## Product Change Notification

PCN #: 20190905-3

Manufacturing process changes in production of coil-terminal subcomponents.

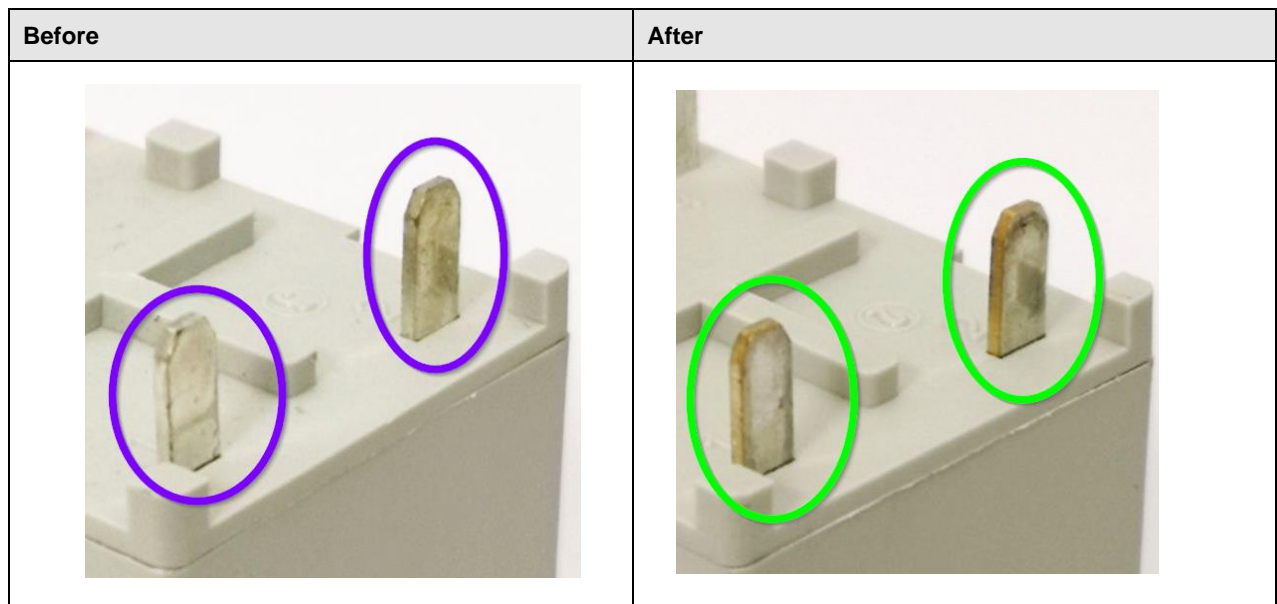
Improvement of part quality and stability of pin insertion process at automating winding machine.

Increase of yield in subcomponent manufacturing by prevention of physical damage of subcomponents during galvanic processes.

Change of raw material and type of tin coating for coil pin of solar relays type AZSR235, AZSR250, AZSR280.

Current process: Stamping of coil-terminal subcomponent from brass tape (CuZn33), then galvanic coating with Sn.

New process: Hot dip tinning of brass tape (CuZn33), then stamping of coil-terminal subcomponent.
